PLANNING BOARD AGENDA Tuesday, November 16, 2021 @ 7:00PM

1. 7:00 PM **Public Hearing, Special Permit**
SP2021-08, 1603-1605 Main Street, (gas station, convenience store, fast food restaurant w/ drive through, self-storage building.) Applicant: Skaff Fuels, Inc.

Re: #1603 – #1605 Main Street,
Leicester, MA
AEA Project 00047

Site Development Plan at #1603 - #1605 Main Street Leicester, Massachusetts

SHEET:
10 of 13

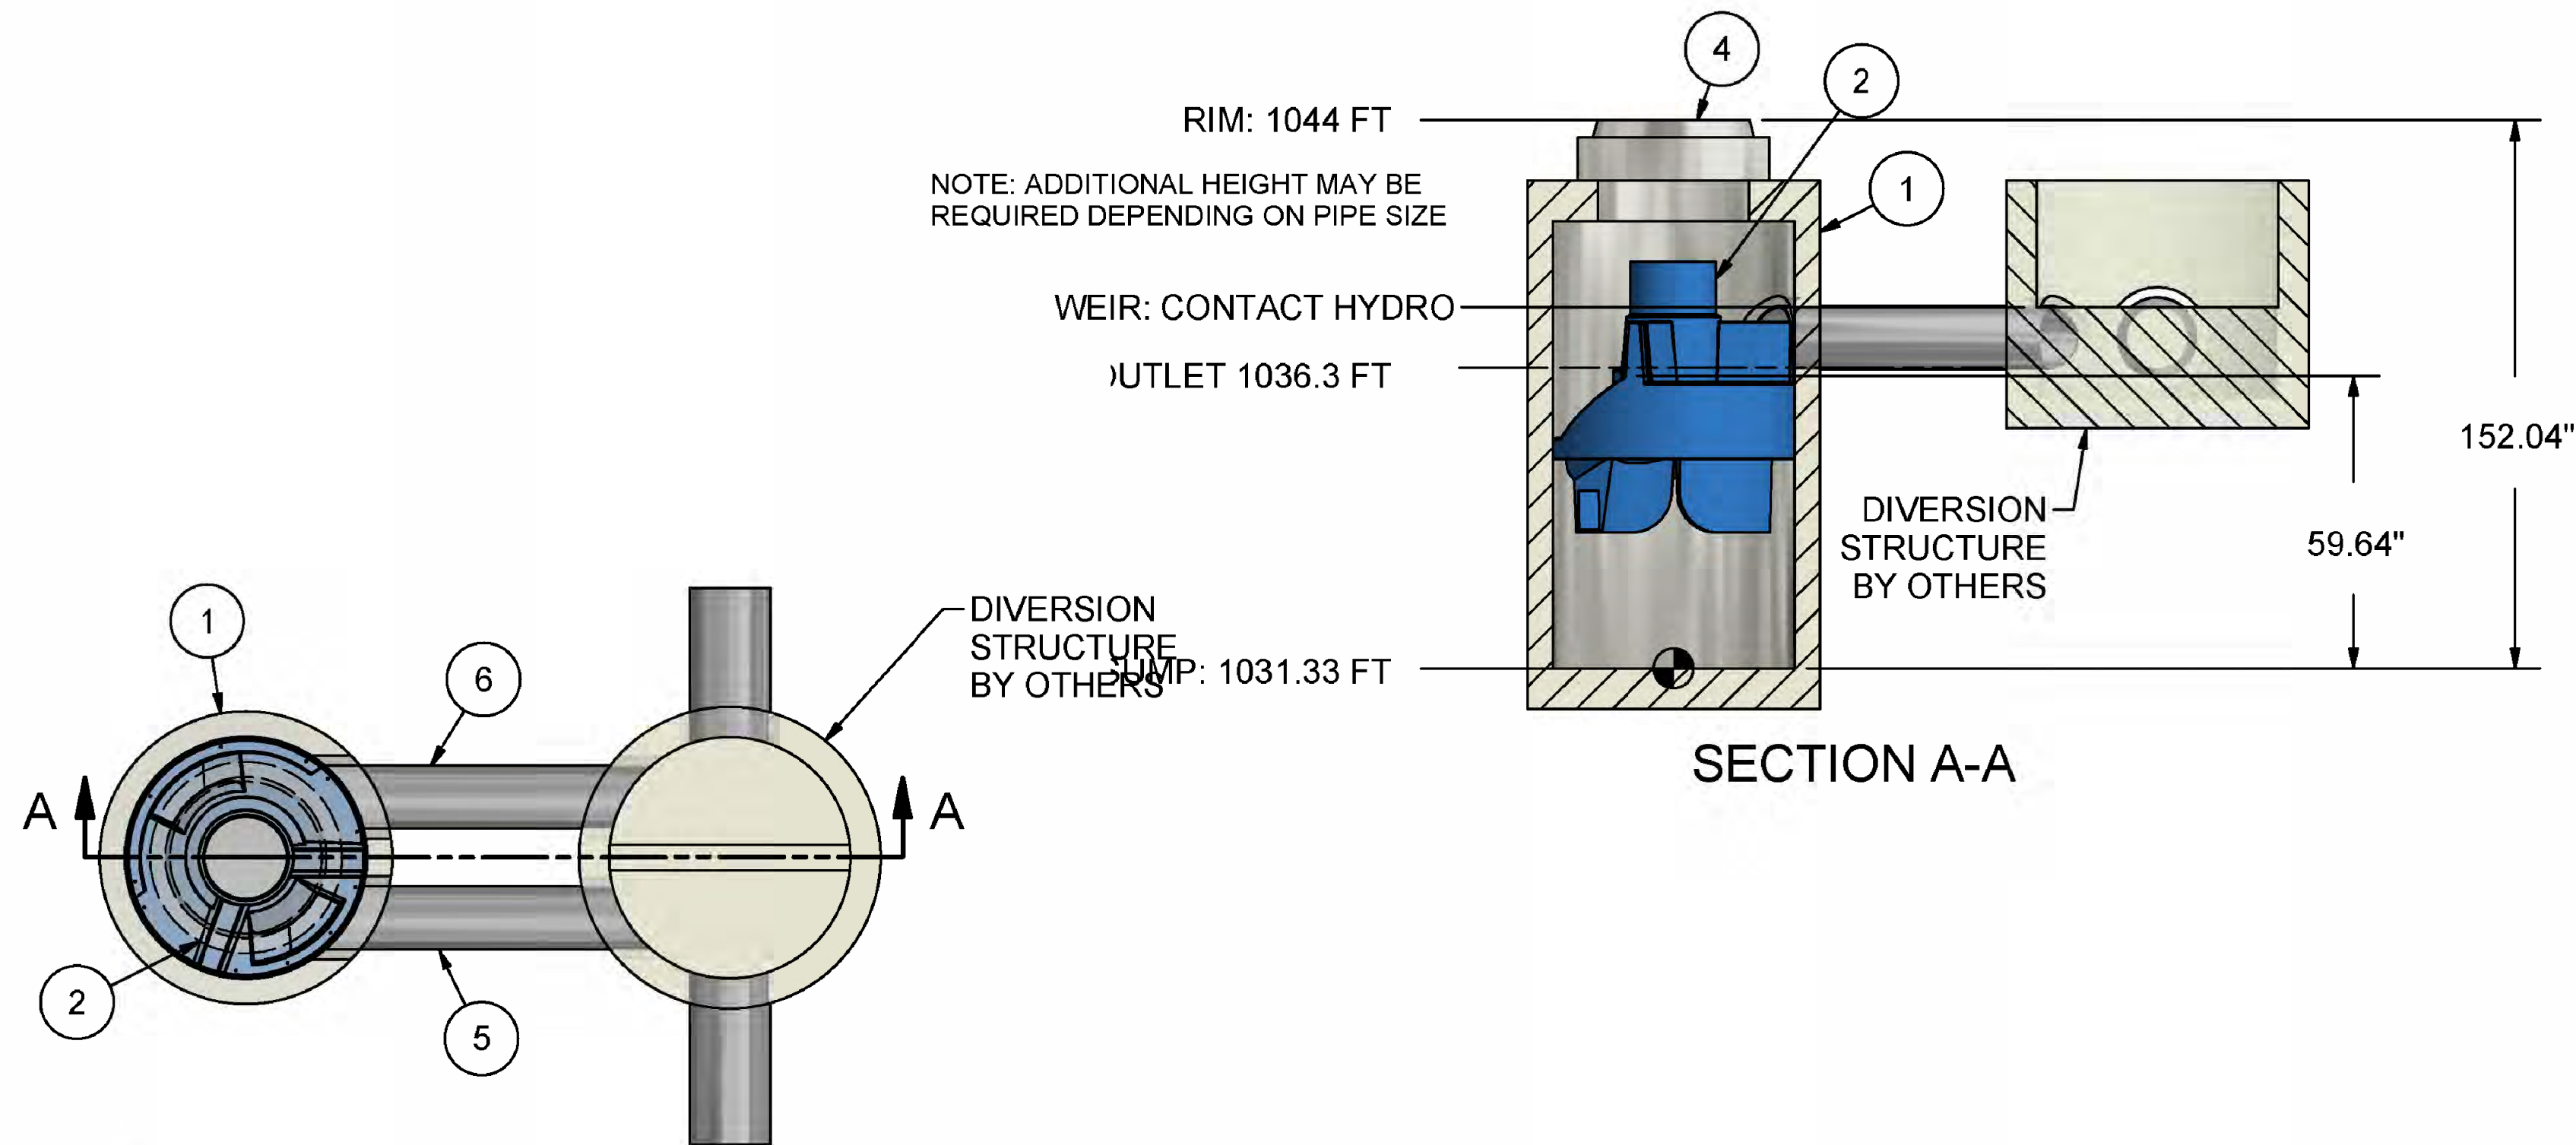
AEA- *Rip rap detail added to sheet 10.*

AEA- *Water infrastructure (curb stops, etc.) will be installed in compliance with the Leicester Water Supply District standard details. Guardrail and fence detail added to sheet 10. Retaining wall details will be provided to the building department during building permit application, if required.*
